RENESAS TECHNICAL UPDATE

Product Category	MPU/MCU		Document No.	TN-RX*-A183B/E	Rev.	2.00
Title	Notes on and Corrections to Descriptions for the P/E Suspension of Flash Memory in RX65N Group and RX651 Group		Information Category	Technical Notification		
Applicable Product	RX65N Group, RX651 Group	Lot No.	Reference Document	RX65N Group, RX651 Group Flash Memory User's Manual: Hardware Interface Rev.2.00 (R01UH0602EJ0200)		
		All

This document describes notes on P/E suspension and corrections to the flow chart of the P/E suspend command in RX65N Group, RX651 Group Flash Memory User's Manual: Hardware Interface Rev.2.00.

Figure 6.13 Usage of the P/E Resume Command

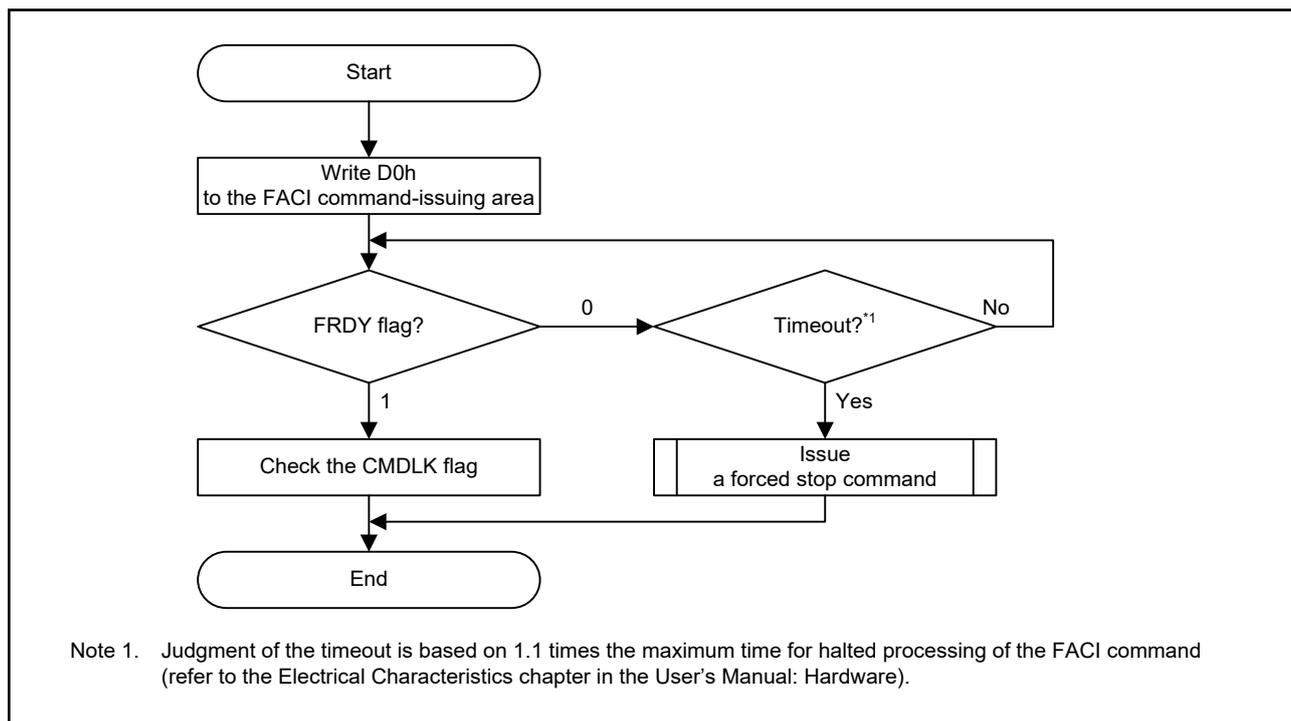
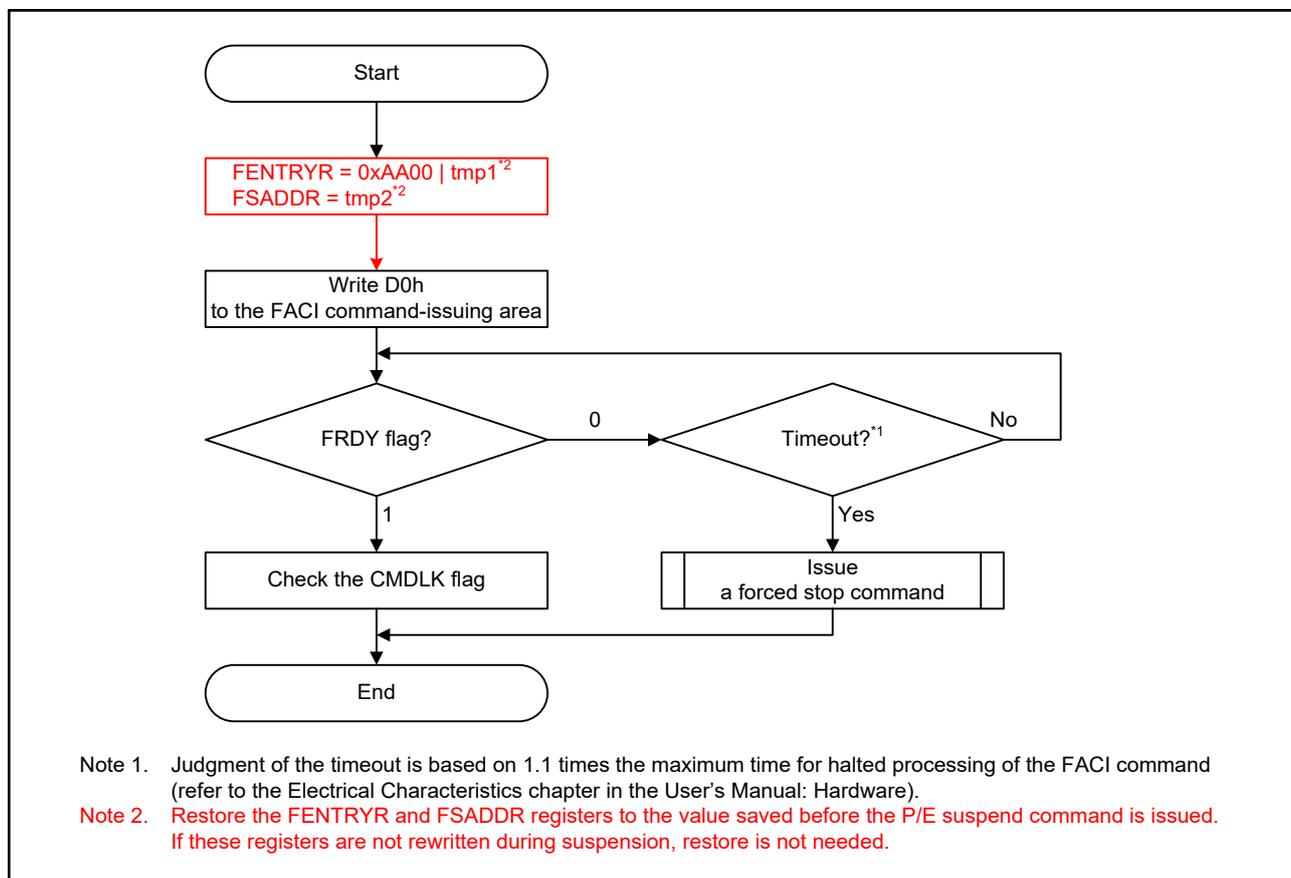
When a programming command is issued for the blocks not to be erased while an erasure operation is suspended, an illegal-command error that should not occur may occur.

When a programming command is issued for the blocks to be erased while an erasure operation is suspended, an illegal-command error that should occur may not occur.

When having changed the value of the FOCI command start address register (FSADDR) while an erasure operation is suspended, restore the value saved before the P/E suspend command was issued to the FSADDR register before issuing the P/E resume command.

Programming to the blocks to be erased is prohibited while an erasure operation is suspended. Do not issue a programming command for the blocks to be erased while an erasure operation is suspended.
